Page 1 — LEFT wall (mic / pad / phones / volume)

Viewed from OUTSIDE the left wall. Left end of template = corner shared with the BLANK (north) wall. Board top at 15 mm below rim. Rev 2: centers f
QuadPreRecorder Rev A / Hammond 1590F — PRINT AT 100% SCALE (no 'fit to page')

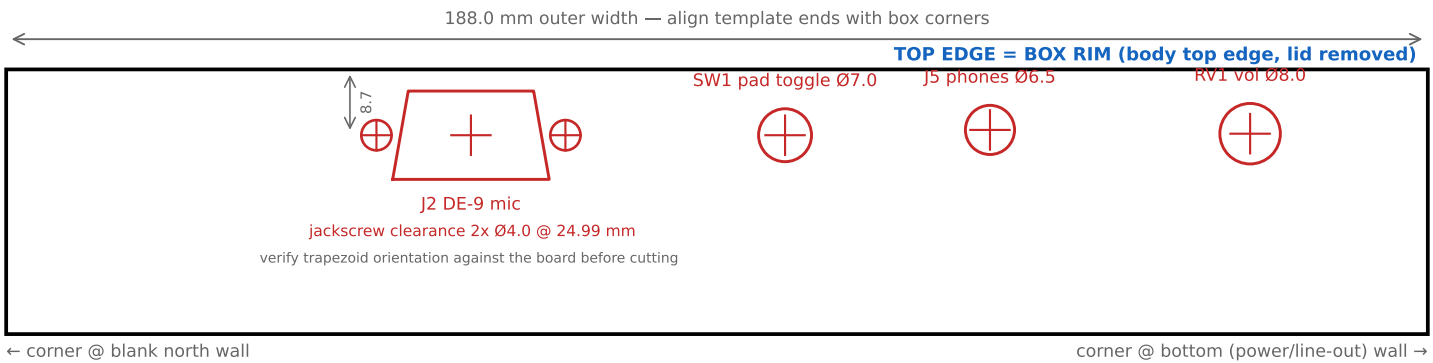
Feature centers from LEFT end of template: J2 = 61.46 SW1 = 103.00 J5 = 130.10 RV1 = 164.50 mm
Centerline depths below rim: J2 = 8.7 (7.8 if EU-style DE-9 is fitted) SW1 = 8.65 J5 = 8.0 RV1 = 8.5 mm.
REV 2 NOTE: J2 moved from 67.0 (was centered on pin 1, not the shell) and RV1 from 162.0 (was the pin-1 anchor, not the shaft). If you drilled from Rev 1 of this template, re-check those two before mounting.
If you change the board depth from 15 mm, shift ALL depths on every wall by the same amount.

SW1 is the E-Switch 100SP 1/4-40 wall toggle: Ø7.0 clearance, no keyway, 8.9 mm bushing through a ~5.5 mm wall — nut + lockwasher outside. WARNING: wall thickens toward the floor.
D-sub mating shells project 6.17 mm — the J2 shell should end ~flush with the outer face.

Page 2 — RIGHT wall (DB-25 debug connectors)

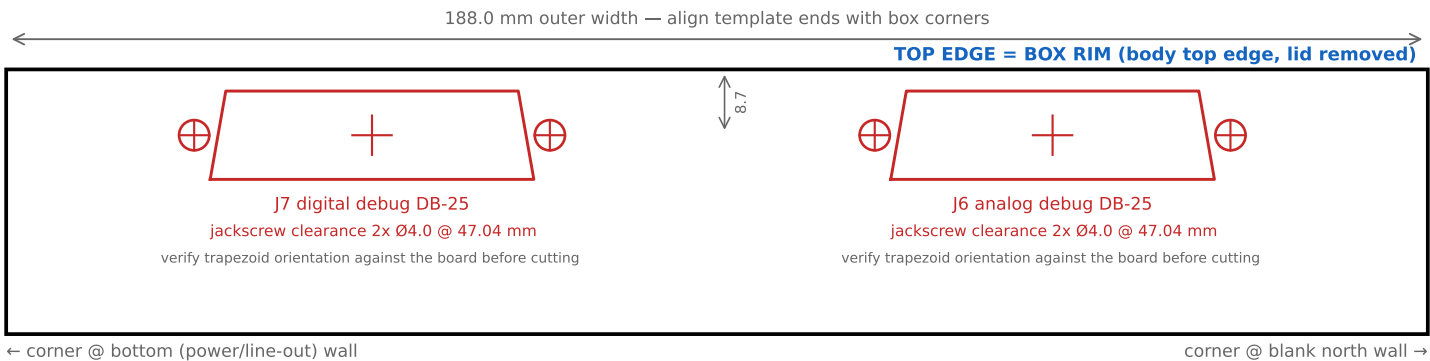
Feature centers from LEFT end of template: J7 = 48.38 J6 = 138.38 mm; both centerlines 8.7 mm below rim.
Cutout 42.8 x 11.68 mm, 10° sloped sides, R2.4 corners (standard front-mount DB-25 punch).
REV 2 NOTE: Rev 1 placed these cutouts on the connectors' pin-1 anchor — 16.6 mm off. These centers are the true shell midpoints measured from the routed board. Do not use Rev 1 for this wall.

Centerline assumes 6.3 mm US-style right-angle DB-25s (matches the LD09-family BOM parts).
Confirm the purchased part's centerline height before cutting.

Page 3 — BOTTOM wall (9 V power + 1/4-inch line out)

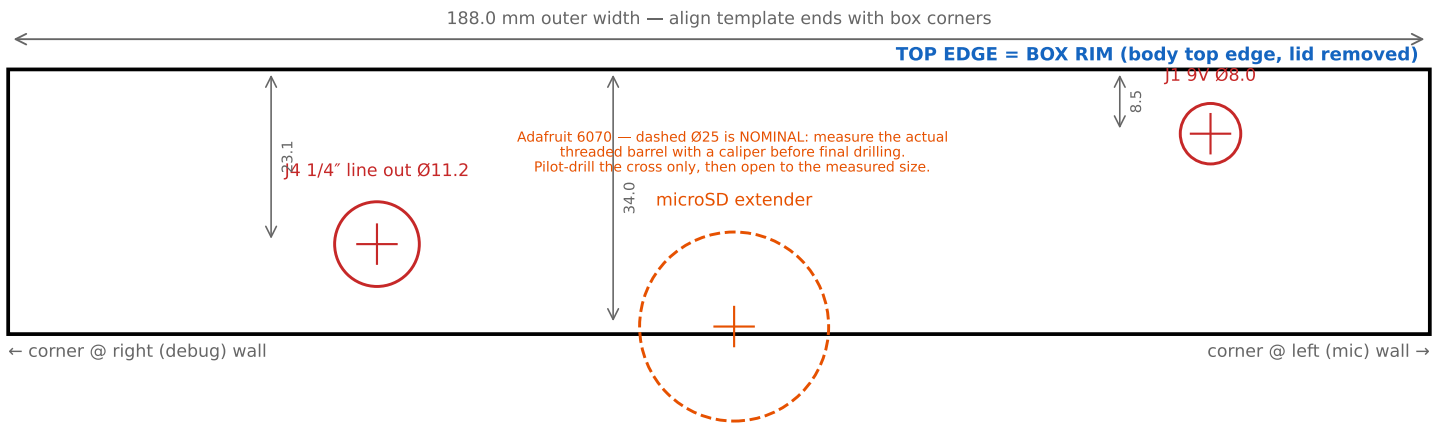
Feature centers from LEFT end of template: J4 = 48.77 microSD = 96.00 J1 = 159.00 mm.
Depths below rim: J4 = 23.1 (bottom-side mount) microSD = 34.0 (below the board) J1 = 8.5 mm.
REV 2 NOTES: this wall now carries J1 (moved off the left wall) and this view is drawn correctly mirrored (Rev 1 was flipped left-for-right AND used J4's pad column, 7.2 mm from the true bushing axis). Do not use Rev 1 for this wall.
REV 4: microSD extender added. Wall is ~7.8 mm thick at 34 mm depth — within the 6070's 16 mm panel rating. Its 18 cm flex plugs into the Teensy 4.1's own card slot (bottom side, SW corner). Neutrik NRJ6HF bushing is 8.9 mm long; wall is ~6.9 mm thick at that depth, leaving ~2 mm of thread. If the nut will not seat, spot-face the outside ~1 mm, or run without the nut (the jack is PCB-anchored).

Page 4 — LID Rev 3 (TFT window + control row below it), 188 x 188

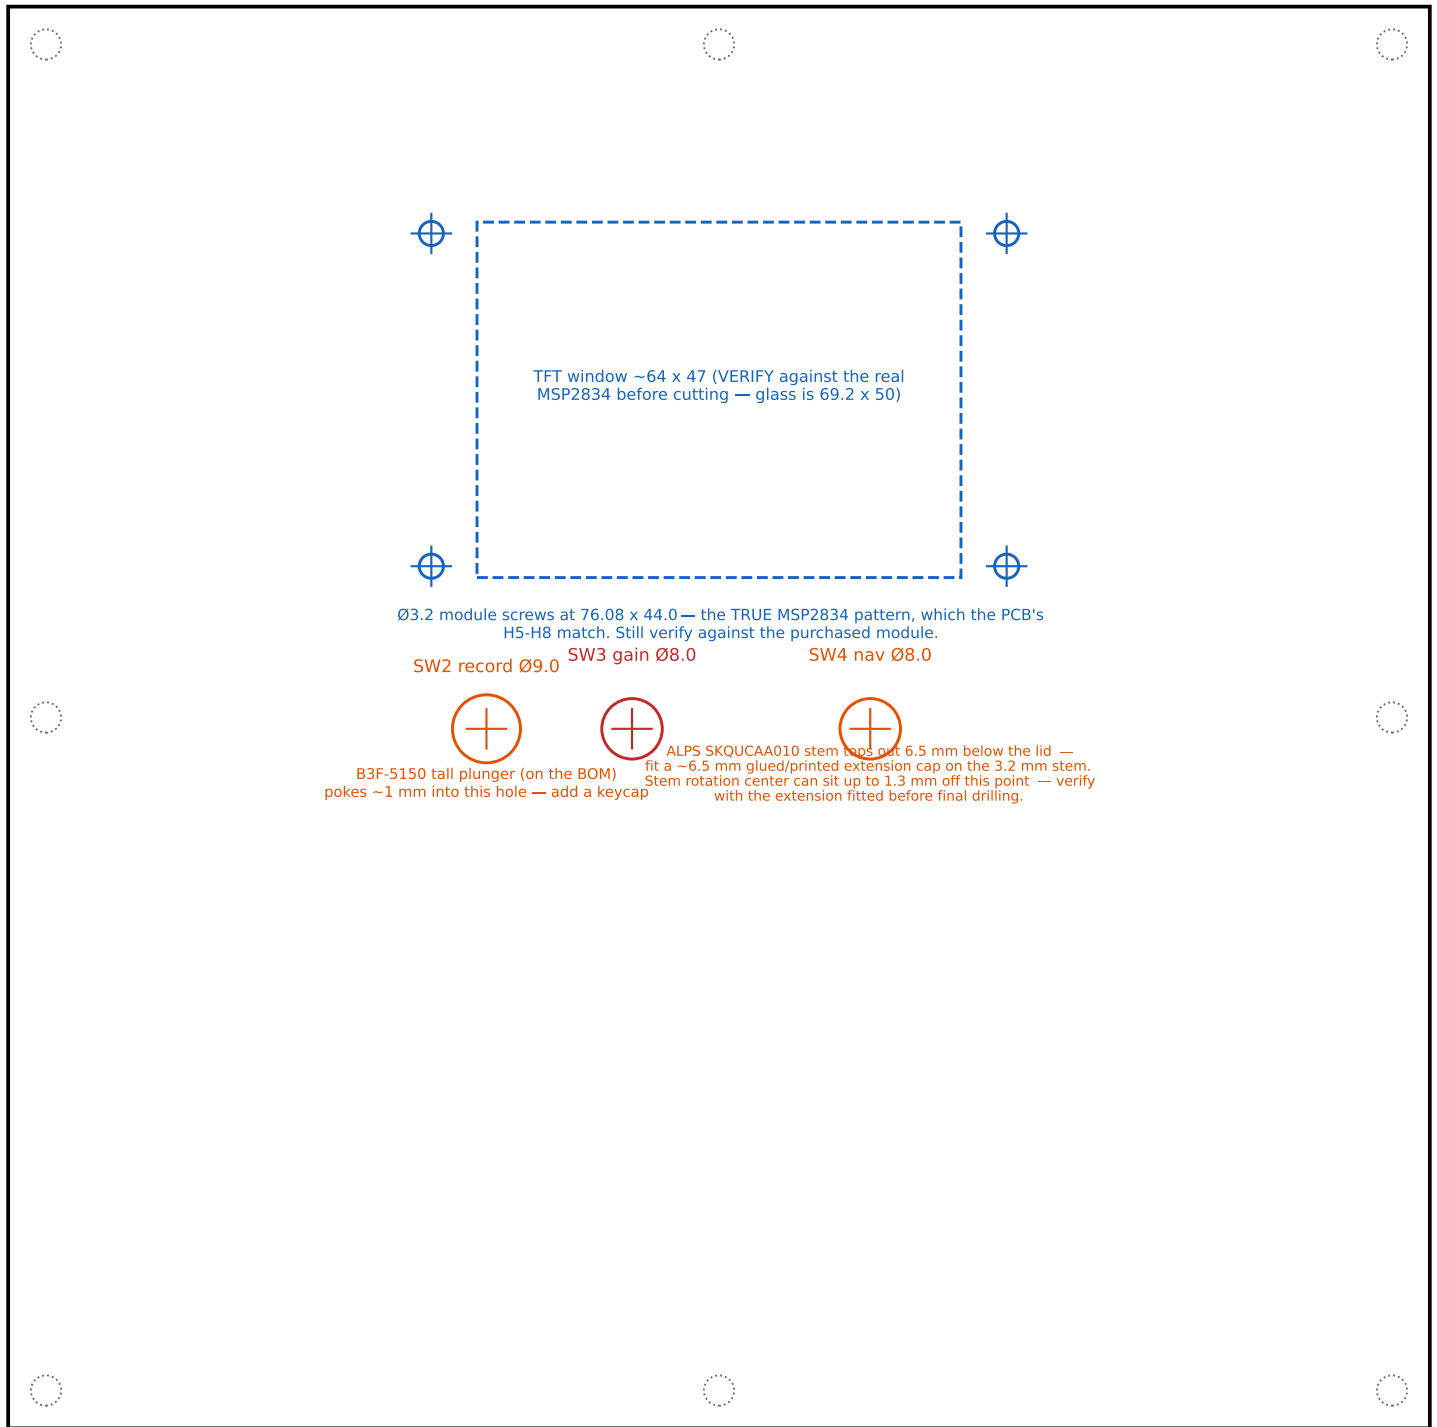
Viewed from OUTSIDE the closed lid. LEFT edge = left (mic) wall side; TOP edge = blank north wall side. Rev 3: REC/GAIN moved below the display and
QuadPreRecorder Rev A / Hammond 1590F — PRINT AT 100% SCALE (no 'fit to page')

Control-row centers from the lid's top-left corner (left = mic wall, top = blank wall):
SW2 record (63.25, 95.5) SW3 gain (82.5, 95.5) SW4 5-way nav (114.0, 95.5) TFT pattern center (94.0, 52.0)
REV 3 NOTES: these are measured actuator centers, not footprint anchors — Rev 2's lid page drew REC/GAIN on their anchors (~6-7 mm off) AND at the old north-edge location. Discard all earlier lid prints.
The pad switch is SW1, a toggle on the LEFT WALL (page 1) — there is no lid slot.
